## DSP-18049

# Walker Mill Road Business Park

STAFF REPORT

SUBJECT:       Detailed Site Plan DSP-18049  
                  Type 2 Tree Conservation Plan TCP2-039-2019  
                  Walker Mill Road Business Park

Figure 1: Proposed Architectural Elevations

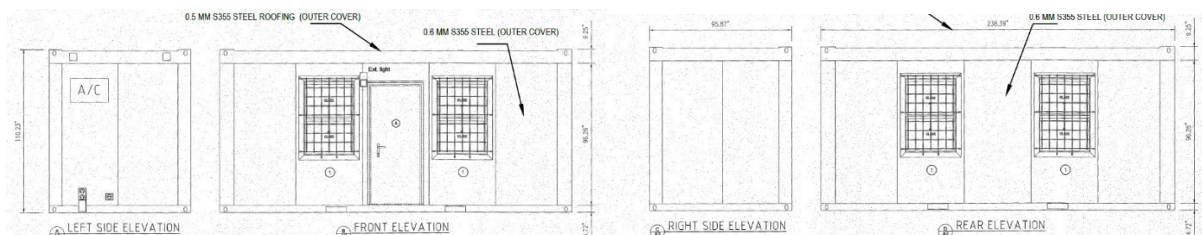
The applicant has proposed a one-story, 160-square-foot, trailer office with a flat roofline that is approximately 9 feet in height. The use of durable, quality materials is proposed on the building and includes steel siding and glass, with an entrance proposed on the front building face. The front and rear elevations are accented by two windows that break up the horizontal face of the building. The side elevations present uninterrupted façades, with no architectural treatments, and continue the steel siding proposed on the front and rear of the building.

Staff recommends additional site and architectural improvements to screen and enhance the appearance of the building from the public right-of-way. Additional treatments include painting the exterior of the building in a neutral color to provide a clean and contemporary finish to the building; installing a skirt at the base of the building to screen the wheels and undercarriage of the structure, in a material and color that will complement the façade of the building; and constructing a minimum 10-foot by 10-foot curbed landscaped island on the southwest side of the building, planted with one shade tree, to screen the building from Walker Mill Road. Conditions are included herein requiring these modifications.

- c. Indicate that the proposed trailer office will be painted a neutral color on all sides and provide a skirt, in a similar material and color, around the entire base to screen the wheels and undercarriage of the structure.

- d. Provide an additional minimum 10- by 10-foot curbed landscape island on the southwest side of the building, planted with one shade tree, to screen the building further from Walker Mill Road.

**Figure 2: Cross Section of Proposed Storage Yard**

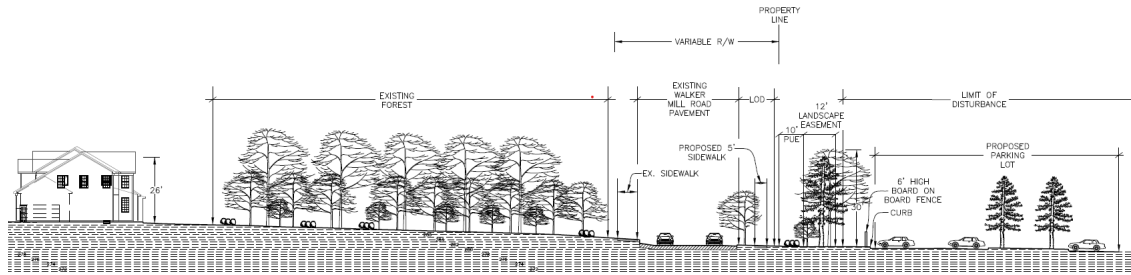
- C. **Provide cross-sections through the subject site to demonstrate that any area of outdoor storage visible from any adjacent right-of-way shall have the solid wood fence specified in condition 1. a.**

A 6-foot-high wooden fence is proposed along the perimeter of the subject property, and the appropriate landscaping is proposed along Walker Mill Road, in accordance with this condition. In addition, the cross-section exhibit submitted with the DSP demonstrates that the outdoor storage area will be sufficiently screened from the public right-of-way.
